**Expert Comments on the Environmental Impact Assessment Report  
for the Sisson Project (Tungsten and Molybdenum Mine),  
New Brunswick  
CEAR #11-03-63169**

**October 11, 2013**

### **Expert Comments on the EIA Report for the Sisson Project (Tungsten and Molybdenum Mine), New Brunswick - CEAR #11-03-63169**

**Figure 1.** Wind rose from Rescan (2008) on the left and the study wind rose (EIAR) on the right. The meteorological station was in the same location for both recordings.

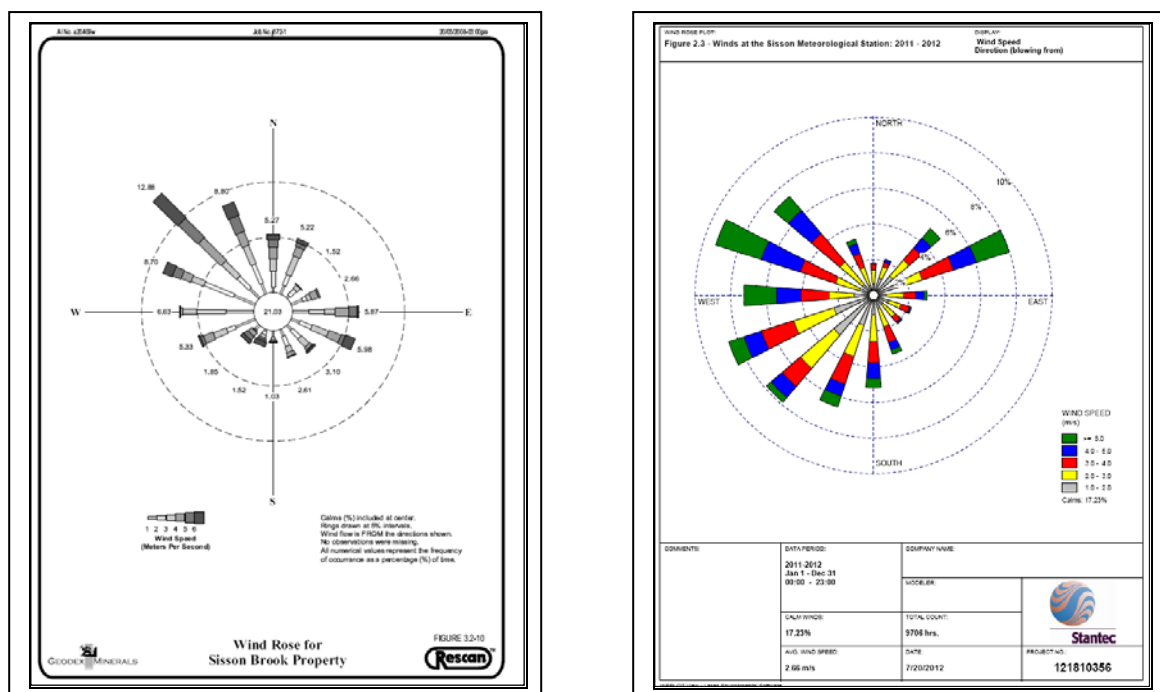
The study referred to "uncertainties" in the quality of the meteorological wind data collected and reported by Rescan (2008) at the open-pit site (AQTR page 14, Sec. 2.3.1). The study suggested that a lack of evidence of station maintenance and quality assurance precluded the use of the RESCAN data (EIAR page 8-14). The study did not elaborate or provide any further discussion as to why the RESCAN data would not be used.

There appears to be a lack of precision (reproducibility) in the meteorological data and considerable uncertainty as to exactly what is being measured. For example, 5 year summaries in two different wind rose plots for the Fredericton Airport, 60 km south of the project area, are presented in the study. One appears on page 8-15 of the EIA report and the other on page 9 of the Baseline Ambient Air Quality Technical Report (Figure 2). The study has suggested that the climate conditions at the project site are comparable to climate conditions in Fredericton. However, neither Fredericton airport 5 year wind rose matched the RESCAN wind rose or the EIA report wind rose for the project site.

**Figure 3.** Five-year wind rose summary for Saint Leonard and Edmundston, New Brunswick. Data Source: NOAA's National Climatic Data Center (NCDC) 2013, <http://cdo.ncdc.noaa.gov/pls/plclimprod/poemain.accessrouter?datasetabbv=DS3505>

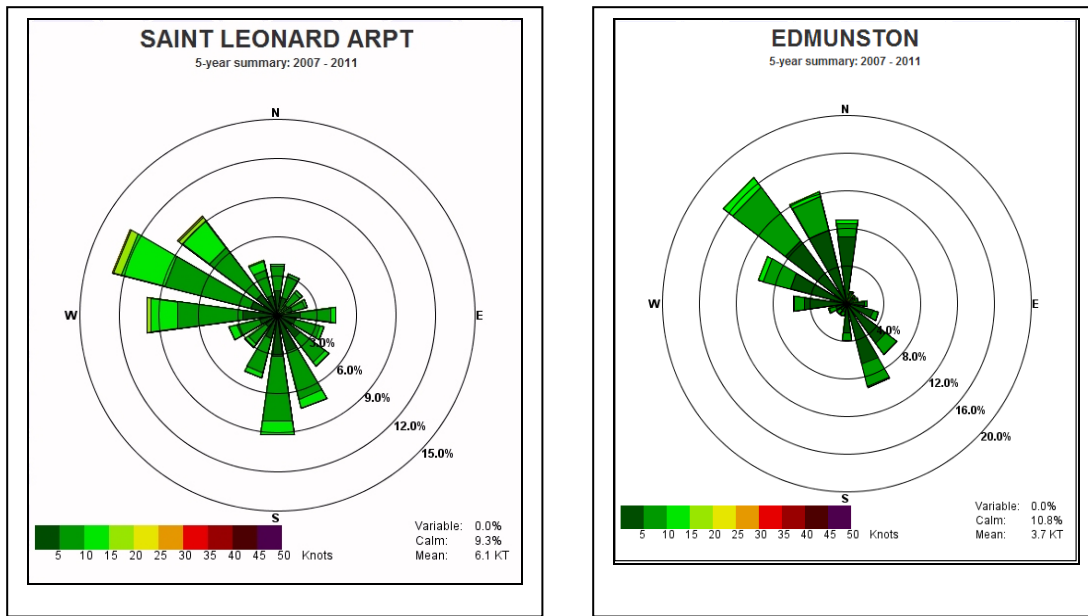
In Figure 3, we present 5-year summary wind rose plots for Saint Leonard and Edmunston (New Brunswick), communities in the central and northern regions of New Brunswick. Wind direction and speed for St. Leonard and Edmunston are more consistent with the RESCAN plot than the proponent's plot, suggesting the regional trend appears to be contradictory to the Fredericton data used in the study.

The meteorological station monitored by both RESCAN and Northcliff Resources for the EIAR was located at the most southerly end of the proposed open-pit at Sisson (AQTR page 15). This location is roughly positioned at 305m above mean sea level. The processing plant, Tailings Storage Facility (TSF), quarry and ammonium paratungstate (APT) plant are located at elevations 385m-400m, an 80 metre differential. Looking at a topographical map, it is clear the meteorological station was located in a localized basin surrounded on three sides by upland terrain. A large fraction of dust emissions from the project will emanate from sources above the open-pit, e.g. the TSF, quarry, processing plant and APT plant. Placing the meteorological station in a relatively sheltered location and below the maximum sources of emissions fails to capture the wind conditions that are critical to assessing the predictions of contaminant dispersion from the project.

Figure A1. Sisson Project: Atmospheric Environment LAA Overlap with Candidate Protected Natural Areas ■ Adapted from Stantec(2013) EIA Report: Figure 8.2.1

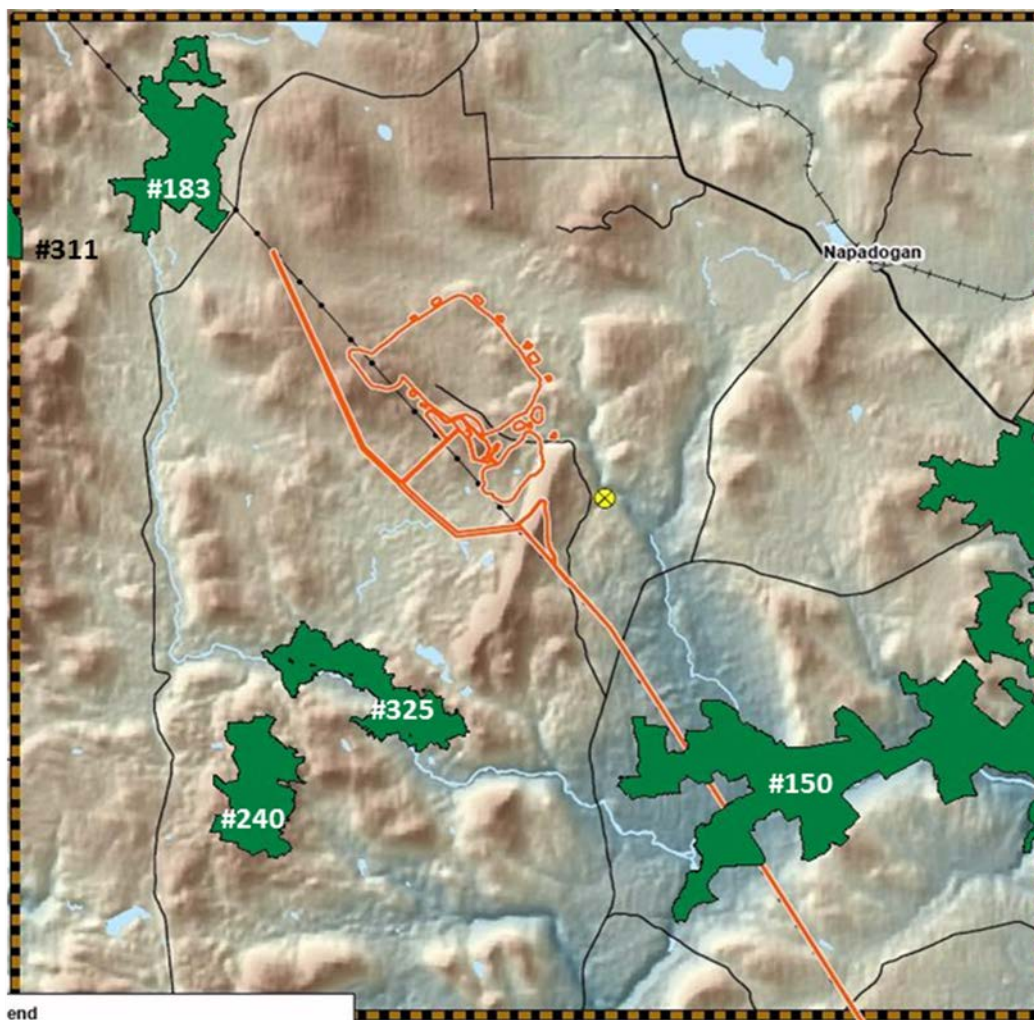
Based on the available mapping of VEC LAAs in Sections 8.2 to 8.17 of the EIA report, the reviewer has analyzed the overlap of candidate PNAs with the LAA of the Atmospheric Environment VEC. This VEC LAA overlaps with 5 candidate PNAs as illustrated in Figure A1 below adapted from EIA report Figure 8.2.1. Without exact geo-location of Figure 8.2.1, the calculation of LAA overlap is approximate only, but some statistics are exact.

Finally, the proponent has failed to appreciate the increased risk to PNA #150 from a tailing dam disaster. The proponent has described the risk of dam failure as not credible. The risk of a dam failure may not be high but it is a credible risk, with approximately 3 tailing dam failures every two years in the world. The impact of a failure on the ecological and economic value of the candidate PNAs must be considered as part of the bonding of this project.
